# Access Compliance Report

## Public Rights-of-Way

Intersection ID: 12968	Main Street: LINCOLN_ST	Cross Street: S_MINT_ST	Location: S
ADA ID: 591BDEB77442	Ramp Type: PerpDiag	Initial Pass/Fail: Fail	Overall Compliance: No
		Severity Score: 25

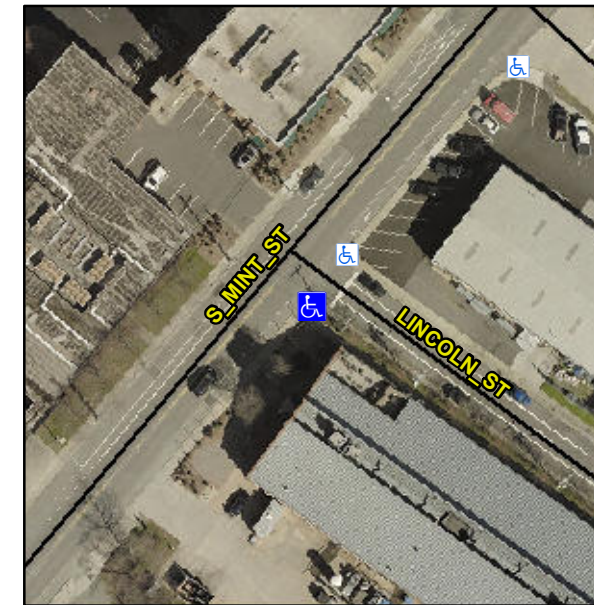
**R304.5.3**

Compliance	Description	Data	Compliance	Description	Data
N/A	Ramp Length (in)	26.0	Yes	Ramp Slope (%)	5.3
Yes	Ramp Width (in)	48.0	No	Ramp XSlope (%)	9.0
N/A	Flare Type LT	N/A	N/A	Flare Type RT	N/A
N/A	Flare Slope LT (%)	N/A	N/A	Flare Slope RT (%)	N/A
N/A	Flare Traversable LT?	N/A	N/A	Flare Traversable RT?	N/A
N/A	Landing Length (in)	N/A	N/A	DWS Provided?	N/A
N/A	Landing Width (in)	N/A	N/A	DWS Contrast?	N/A
N/A	Landing Slope (%)	N/A	N/A	DWS Length (in)	N/A
N/A	Landing X Slope (%)	N/A	N/A	DWS Full Width?	N/A
N/A	Landing Curb? (Y/N)	N/A	N/A	DWS Offset (in)	N/A
N/A	Shared Landing?	N/A			
N/A	Gutter Ponding?	N/A	N/A	Gutter Slope (%)	N/A
N/A	Gutter Lip Ht (in)	N/A	N/A	Gutter X Slope (%)	N/A
N/A	Painted X Walk1?	No	N/A	Painted X Walk2?	No
	X Walk 1 Direction	To NE		X Walk 2 Direction	To NW
N/A	X Walk 1 Width (in)	N/A	N/A	X Walk 2 Width (in)	N/A
	X Walk 1 Slope (%)	2.1		X Walk 2 Slope (%)	6.6
	X Walk 1 X Slope (%)	5.5		X Walk 2 X Slope (%)	1.9

**Remove & Replace Curb Ramp With Two New Directional Ramps or Equivalent.**
